3980 Walker Road Final Drainage Report

Subdivision: Walker Reserve (Lot 3)

Date Prepared: June 2024

PCD No. PPR2350

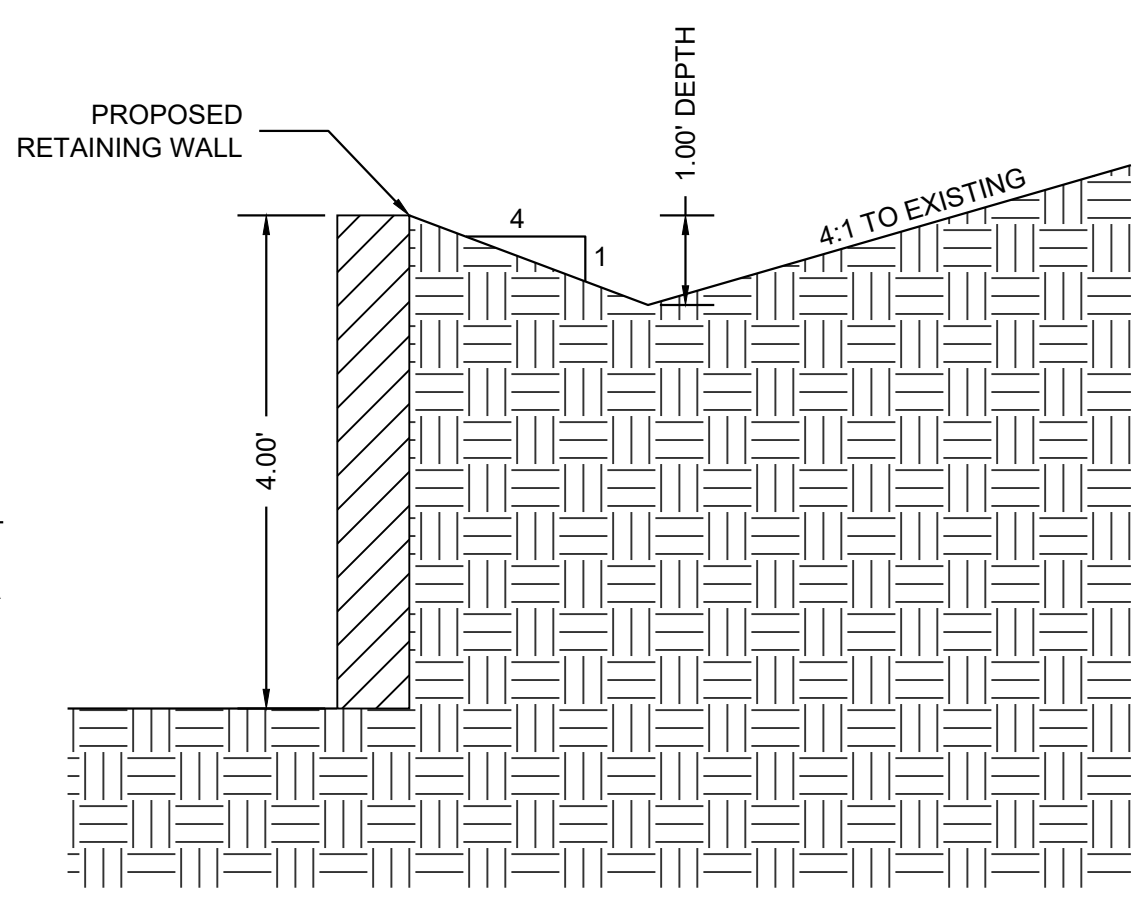
Runoff Reduction calcs and map are provided on pages 43 and 44 below but are not discussed in the report text at all. Please discuss in these sections and anywhere else you deem appropriate. As-is, it's confusing to state that the site is excluded from needing WQ but then provide WQ calcs. You can just state that those calcs are provided for reference only.
